Certificate of Appropriateness

Property 2652-54 W. FOND DU LAC AV.
Description of work Build new storefront; install new windows; tuckpoint as needed, construct addition.
Date issued 10/4/2006 PTS ID 757 COA - Storefront addition.

PROPOSED ALTERATIONS AND ADDITIONS TO
HISTORIC VAN ELLS BUILDING FOR CFSC
 262-54 N. POND DR LAC AVE. MILWAUKEE, WI

SOUTH ELEVATION

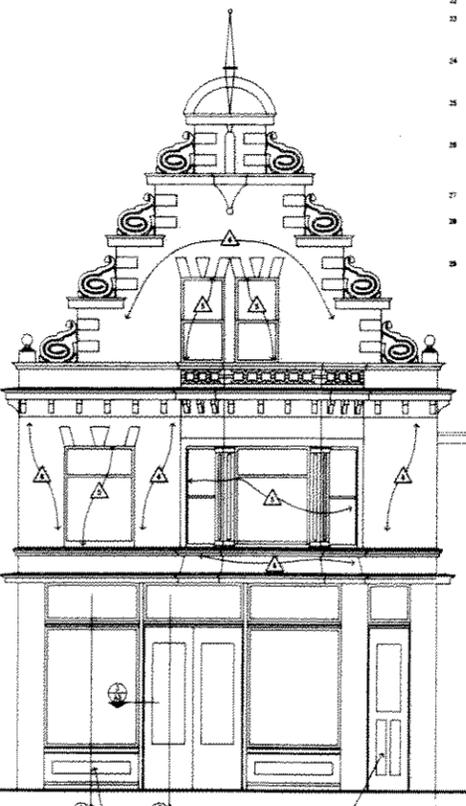
New addition to south elevation will be separated by a gangway approximately 6' wide and 16' deep. Any new wood windows on building must be wood inside and out and must match existing window sizes. No blocking down of window size is permitted. All finish wood must be smooth and free from knots and sapwood. All wood must be painted as soon as possible to protect from weather. Please note that research has shown that when new bare wood is exposed to the elements for a period of only a week or two, the life of the paint job applied to it is likely to be decreased. New mortar for tuckpointing must match old in terms of color, texture and joint finish; sound mortar must not be removed. Please note that mortar, which is too hard, is prone to premature failure. See "Good for Business" masonry chapter for a detailed explanation. The work must be done according to the attached drawings and/or photos, any changes must be approved by HPC staff.
